Access Compliance Report

Public Rights-of-Way

(Curb Ramps)

| Intersection ID: 6527 | Main Street: FAIRES_FARM_RD | Cross Street: PAMELA_LORRAINE_DR | Location: NW |

| ADA ID: 1B6A5D24F2A8 | Ramp Type: Perp | Initial Pass/Fail: Fail | Overall Compliance: No |

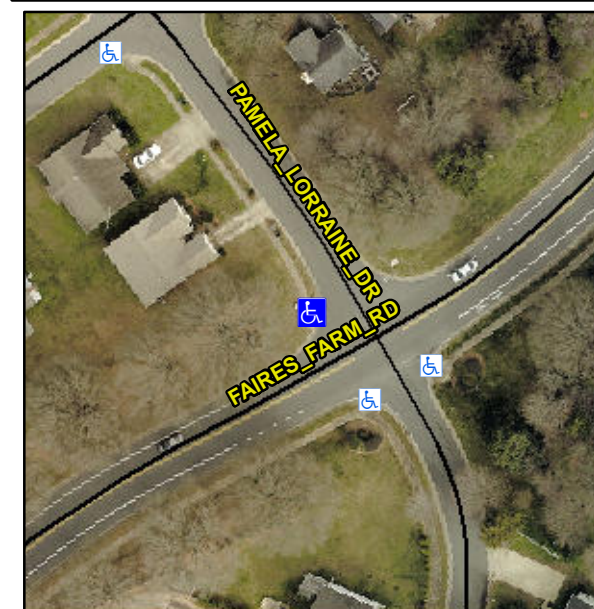
Not Found, R304.5.1, R304.5.3

| Compliance | Description | Data | Compliance | Description | Data |
|------------|-----------------------|-------|------------|-----------------------------|------|
| N/A | Ramp Length (in) | 48.0 | Yes | Ramp Slope (%) | 6.2 |
| No | Ramp Width (in) | 34.0 | No | Ramp XSlope (%) | 2.3 |

Remove & Replace Entire Ramp.
